**AGENDA
FARRAGUT MUNICIPAL PLANNING COMMISSION**

**October 17, 2019
7:00 p.m. Farragut Town Hall**

SUBJECT: Discussion and public hearing on a site plan for the Top Golf, 11400 Outlet Drive, 15.73 Acres, Zoned OD-RE/E (Land Development Solutions, Applicant)

RECOMMENDATION: Included in your packet is a copy of the site plan, other select plan sheets, and staffs' initial comments (in Bluebeam format) with the applicant's response. Staff will make a recommendation at the meeting based on whether staffs' comments have been satisfactorily addressed.

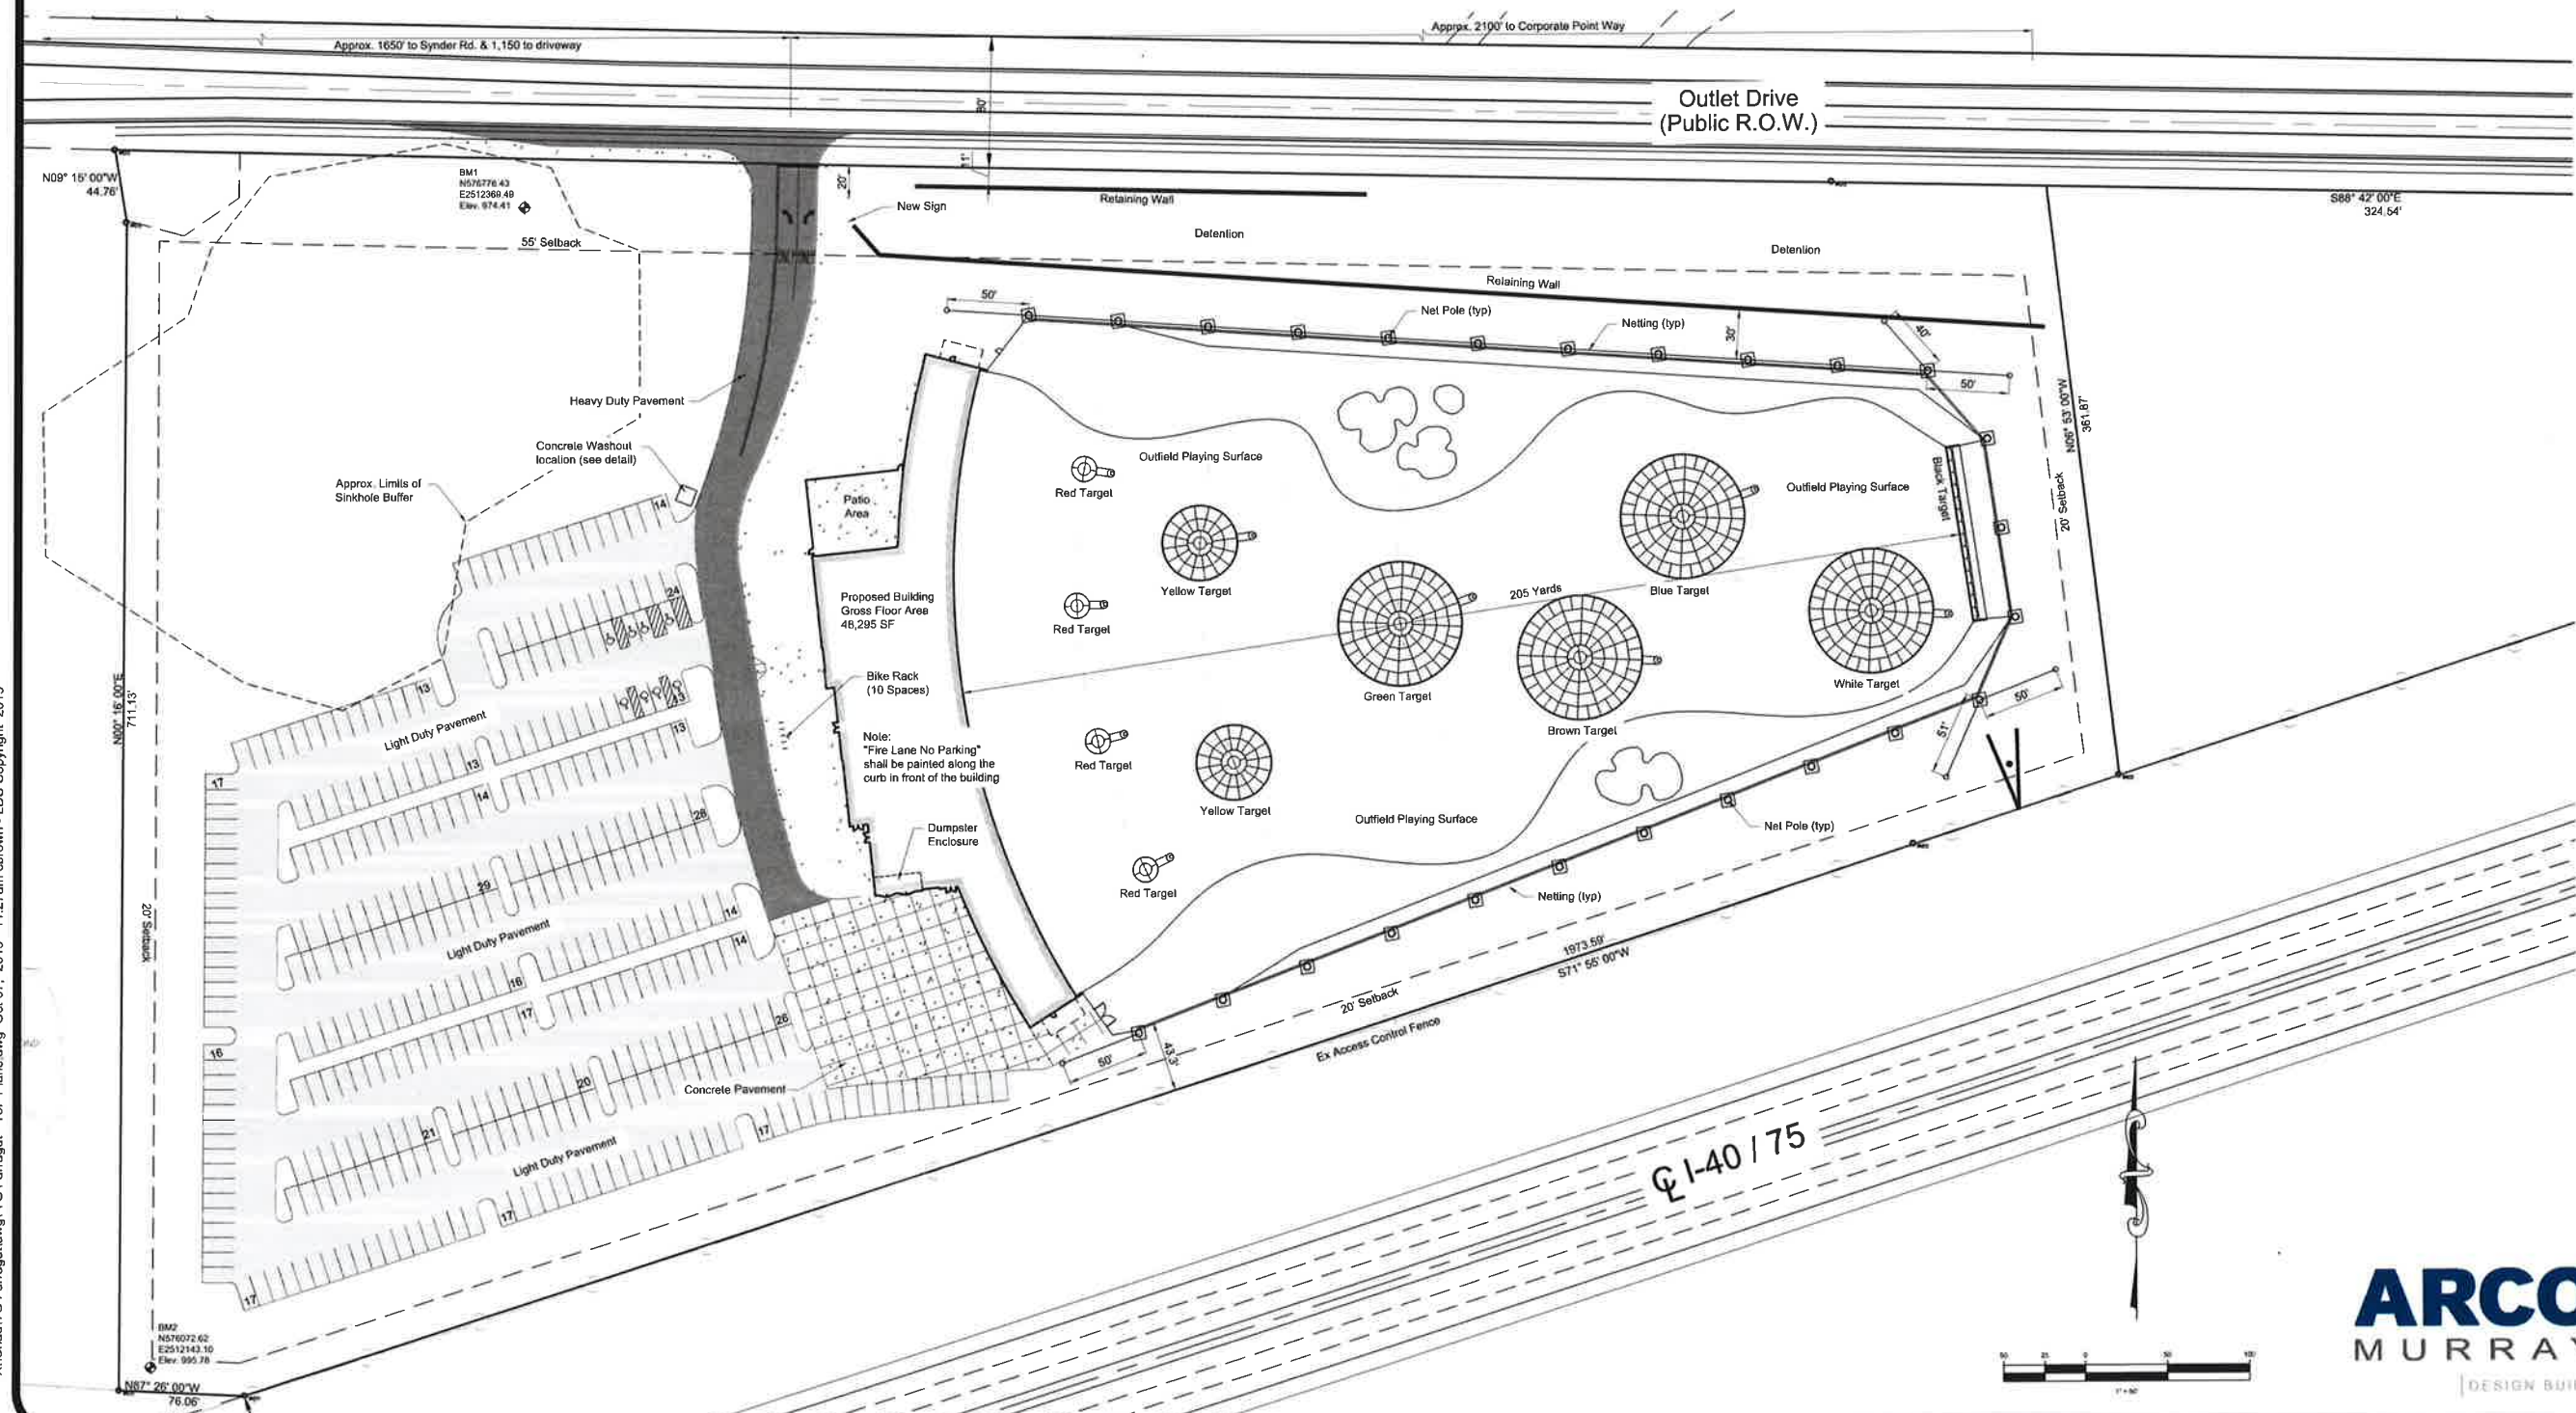
A signed and sealed drawing will be required for the final revised set of sheets. Concept drawings will not work for the final approval (1)

A signed and sealed drawing will be required for the final revised set of sheets. Concept drawings will not work for the final approved set.

Noted. Stamped Plans have been included in this submittal

C3.0

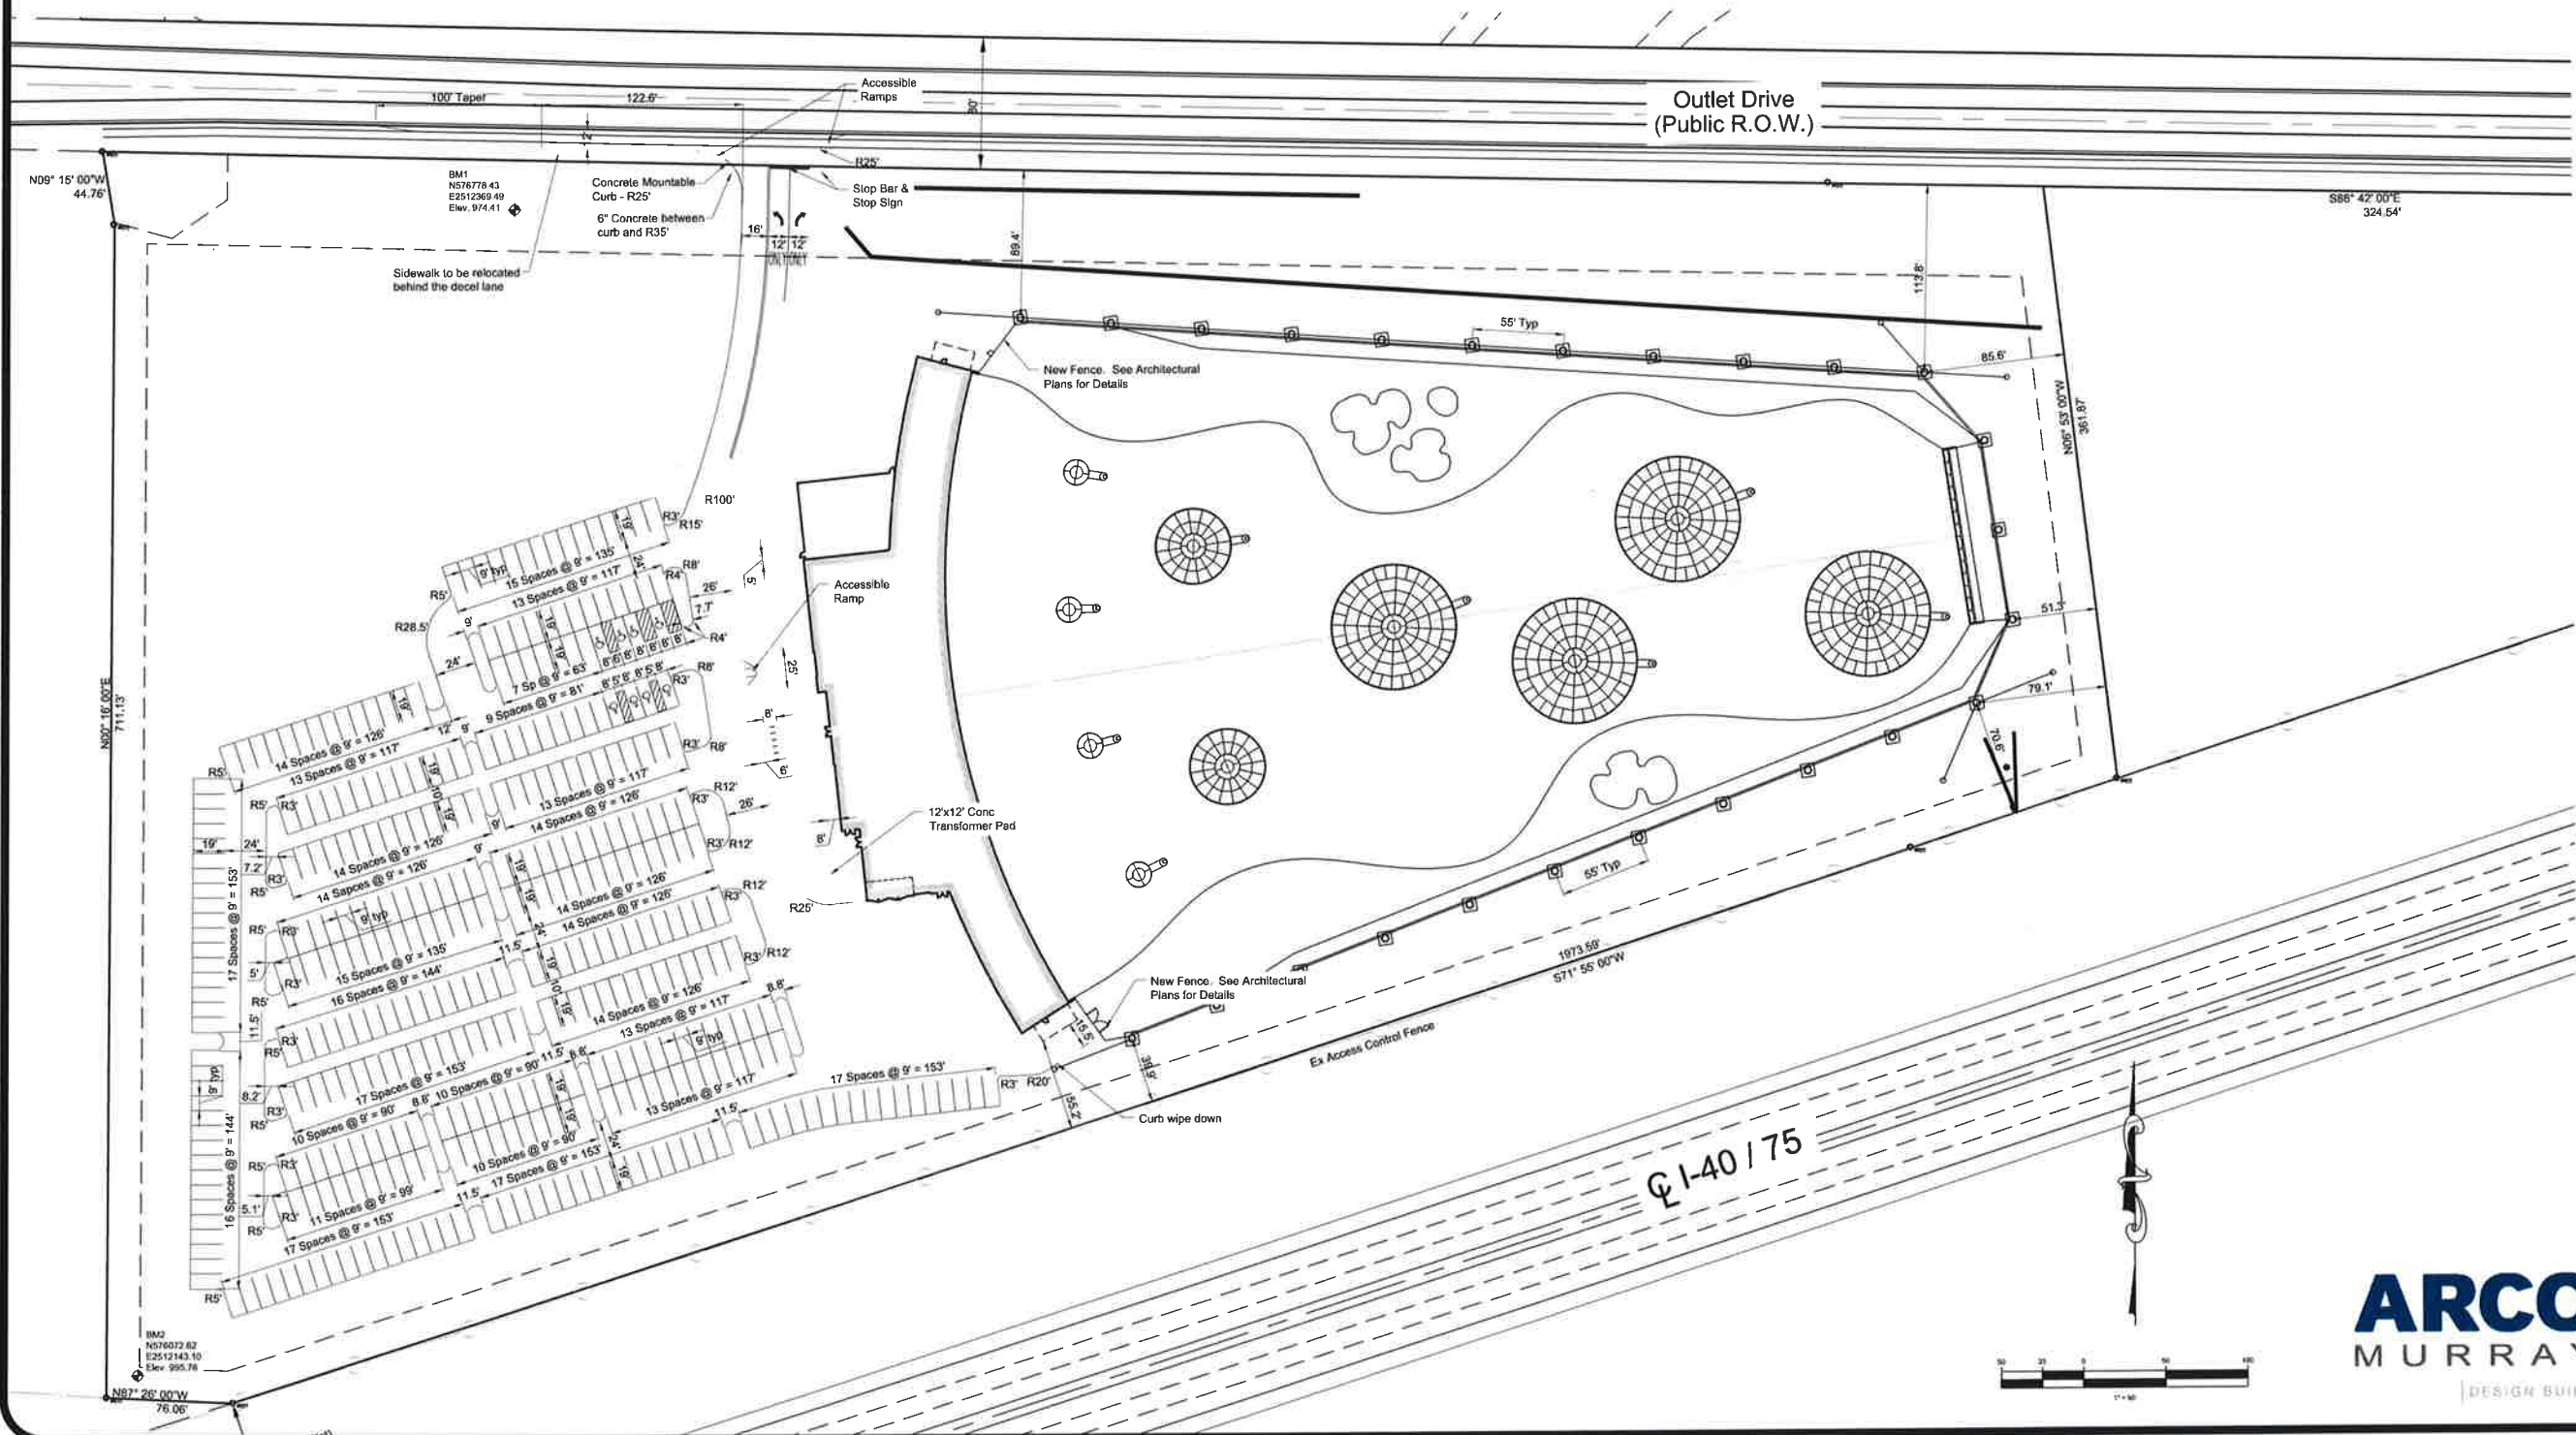
Provide location of fire sprinkler PIV (1)

Provide location of
fire sprinkler PIV

Provide FDC (1)

Provide FDC

Coordinate with fire truck detail on sheet C3.2 (1)

Coordinate with fire truck detail on sheet C3.2

PIV to be located on the
front of the building.
See Sheet 10 of 45

FDC to be located on the
front of the building.
See Sheet 10 of 45

Noted. This area has been coordinated with Sheet 7 of 45

Plan View:WHOLE SITE
Scale: 1 inch= 50 Ft.

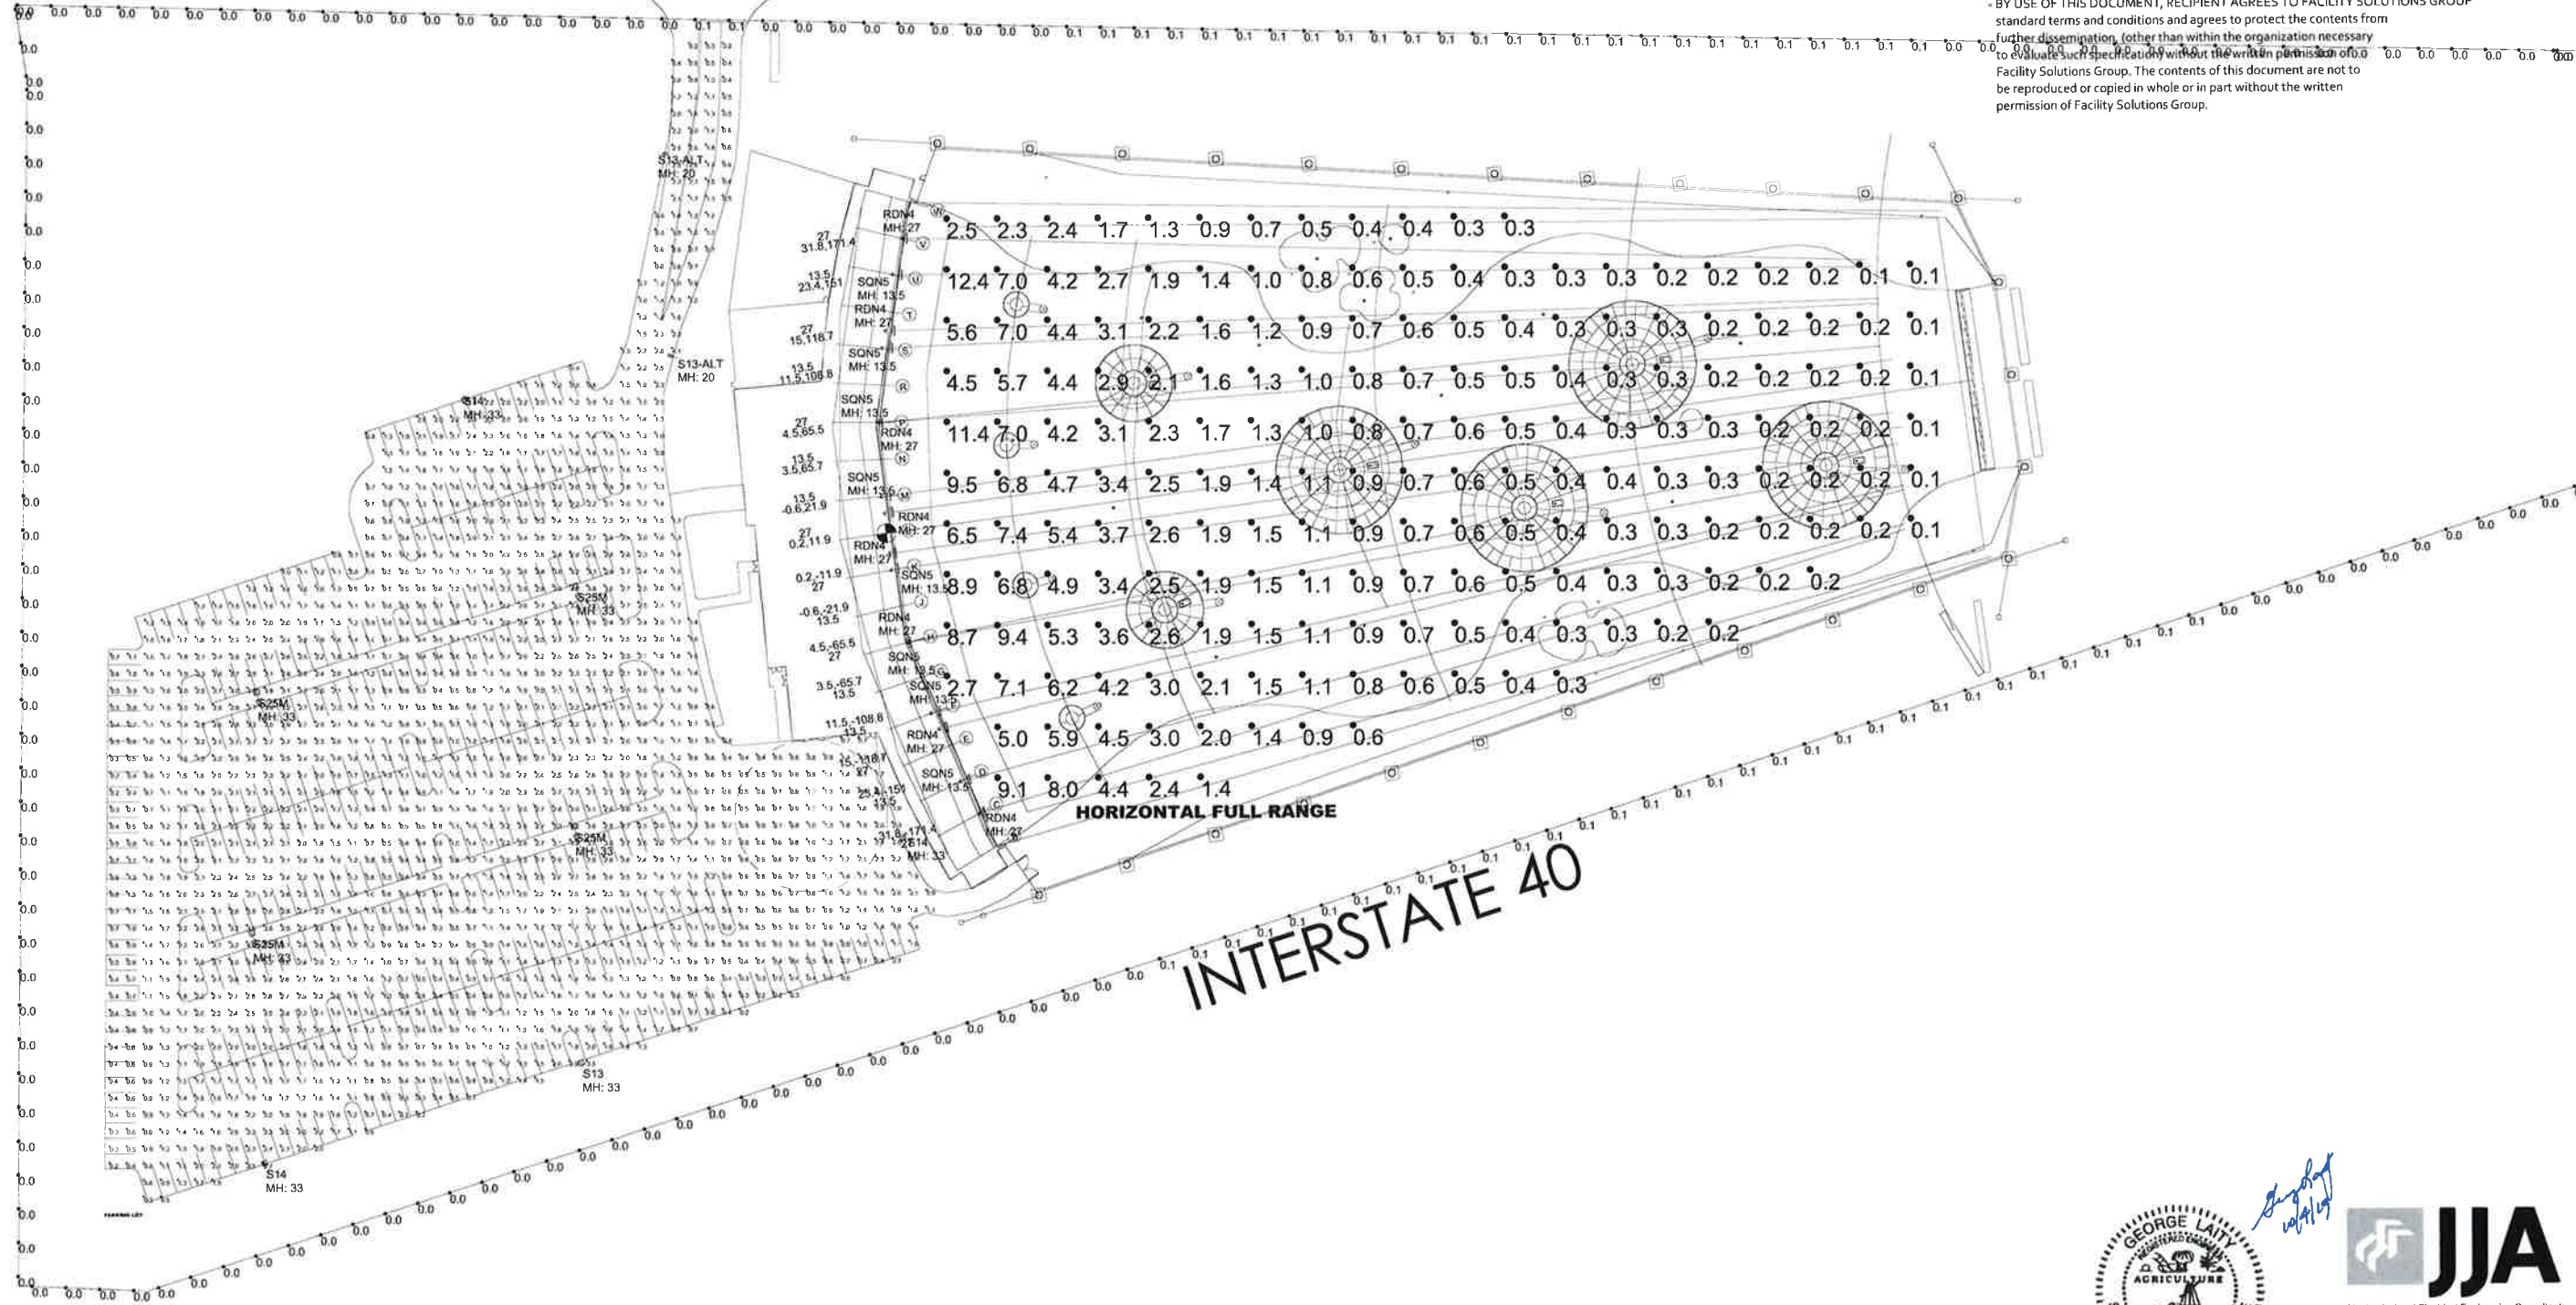
Please see comments on the lighting plan sheets. An additional comment is to ensure that the plan clearly identifies and includes

Please revise to include the lighting specific to this zoning district. (1)

Please revise to include the lighting specific to this zoning district.

Additional sheets were added to Sheet 3 (sheet 45 of 45) of the Photometric Package, as well as additional spec sheets to the resubmittal package. This includes details of the GameChanger 500 fixture (note the GameChanger 1000 is NOT proposed on this project). A comparison document of this bar LED system is compared to the previous lighting package (metal halide), explaining how glare is reduced. The fixtures are aimed downwards toward the front half of the outfield - this can be shown by the higher foot candle readings on the photometric plan in the half of the outfield closer to the light sources. Additionally, a shield is proposed in order to further

The plan identifies and includes cut sheet details for the proposed lighting. The second sheet shows the parking lot fixture, of which there are 10 proposed per the site plan on the first sheet. The third sheet shows the teeline fixtures meant to illuminate the outfield, of which there are 16 proposed per the site plan on the first sheet and table on the third sheet.

Sheet 44 of 45 has been revised to include the lighting standards specific to this zoning district.
